ADDENDUM NO. 1

**BURIAL VAULTS AND COLUMBARIUM NICHE WALLS
NORTHERN MAINE VETERANS' MEMORIAL CEMETERY
CARIBOU, MAINE**

Date: MAY 5, 2015

Sheet Title:
Pump Control &
Electric Service
Schematic Plan

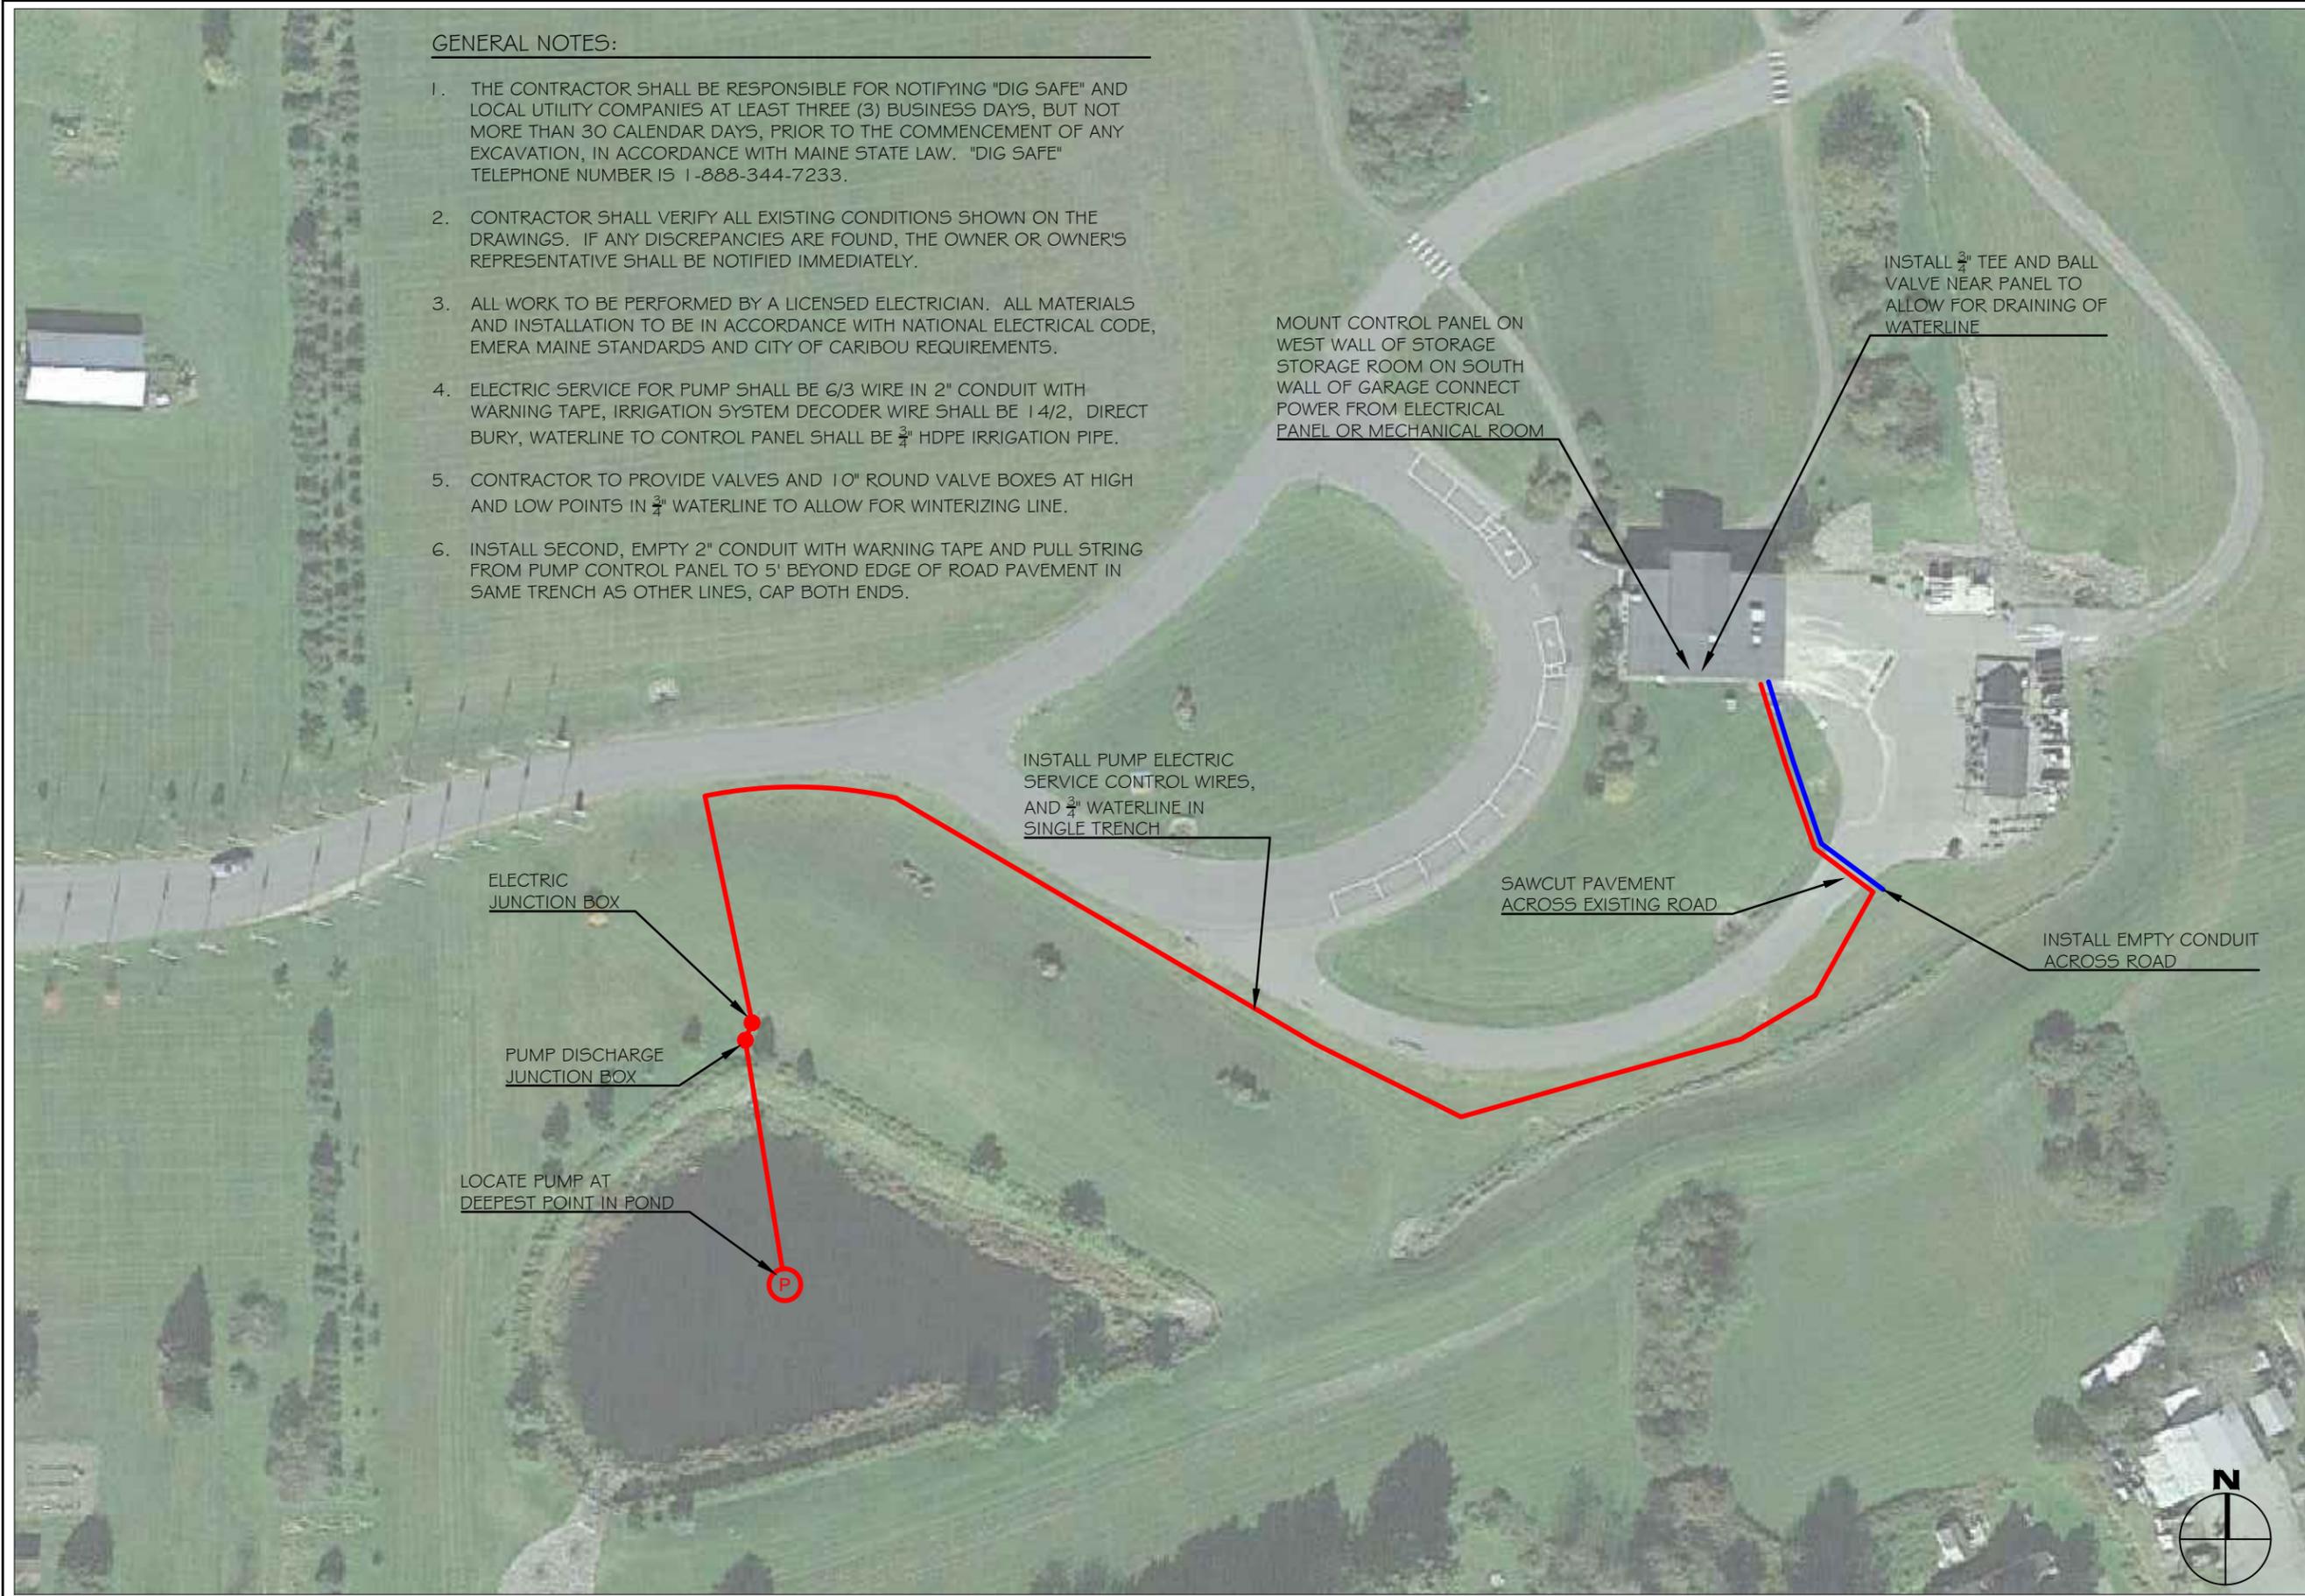
- C1.01 **Design Change:** To facilitate winterization of the irrigation system, the routing of the ¾” waterline from the pump to the control panel has been revised and additional valves and valve boxes have been added. Also, the control panel has been relocated in the garage.
Specifications: Replace Appendix D of the specifications with the attached Appendix D dated May 5, 2015.
- C1.02 **Contractor Question:** “: There is a detail for sod on the plans. Is there any area(s) on the job that requires sod?”
Clarification: The area over the burial crypts and out to ten (10) feet on all sides and all the disturbed areas around the columbariums shall be sodded.
- C1.03 **Design Change:** The detail for pavement thickness of the access road was omitted from the plans.
Plans: See sheet C5.5 dated May 5, 2015 attached to this addendum.

5. CONTRACTOR TO PROVIDE VALVES AND 10" ROUND VALVE BOXES AT HIGH AND LOW POINTS IN 3/4" WATERLINE TO ALLOW FOR WINTERIZING LINE.
6. INSTALL SECOND, EMPTY 2" CONDUIT WITH WARNING TAPE AND PULL STRING FROM PUMP CONTROL PANEL TO 5' BEYOND EDGE OF ROAD PAVEMENT IN SAME TRENCH AS OTHER LINES, CAP BOTH ENDS.
